Access Compliance Report

Public Rights-of-Way

(Curb Ramps)

Intersection ID: 45164	Main Street: ELESSAR_PL	Cross Street: ARAGORN_LN	Location: W
ADA ID: ED0EA3B84EAB	Ramp Type: Perp	Initial Pass/Fail: Fail	Overall Compliance: No
Severity Score: 13.75			
Codes/Mitigation Info/Possible Solution		Field Measurements/Component Compliance

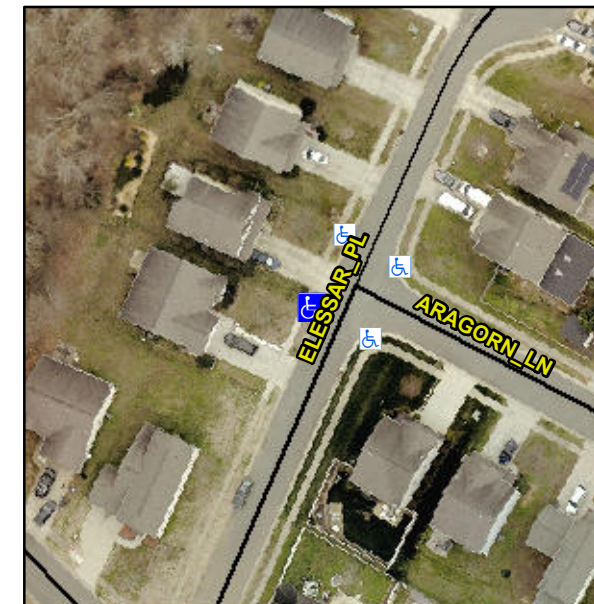
PROW/ADA:

R304.2.2

Compliance	Description	Data	Compliance	Description	Data
N/A	Ramp Length (in)	48.0	No	Ramp Slope (%)	11.6
Yes	Ramp Width (in)	48.0	Yes	Ramp XSlope (%)	2.6
N/A	Flare Type LT	N/A	N/A	Flare Type RT	N/A
N/A	Flare Slope LT (%)	N/A	N/A	Flare Slope RT (%)	N/A
N/A	Flare Traversable LT?	N/A	N/A	Flare Traversable RT?	N/A
N/A	Landing Length (in)	N/A	N/A	DWS Provided?	N/A
N/A	Landing Width (in)	N/A	N/A	DWS Contrast?	N/A
N/A	Landing Slope (%)	N/A	N/A	DWS Length (in)	N/A
N/A	Landing X Slope (%)	N/A	N/A	DWS Full Width?	N/A
N/A	Landing Curb? (Y/N)	N/A	N/A	DWS Offset (in)	N/A
N/A	Shared Landing?	N/A			
N/A	Gutter Ponding?	N/A	N/A	Gutter Slope (%)	N/A
N/A	Gutter Lip Ht (in)	N/A	N/A	Gutter X Slope (%)	N/A
N/A	Painted X Walk1?	No	N/A	Painted X Walk2?	N/A
	X Walk 1 Direction	To SE		X Walk 2 Direction	N/A
N/A	X Walk 1 Width (in)	N/A	N/A	X Walk 2 Width (in)	N/A
	X Walk 1 Slope (%)	2.6		X Walk 2 Slope (%)	N/A
	X Walk 1 X Slope (%)	6.5		X Walk 2 X Slope (%)	N/A

Possible Solutions:

Remove & Replace Entire Ramp.
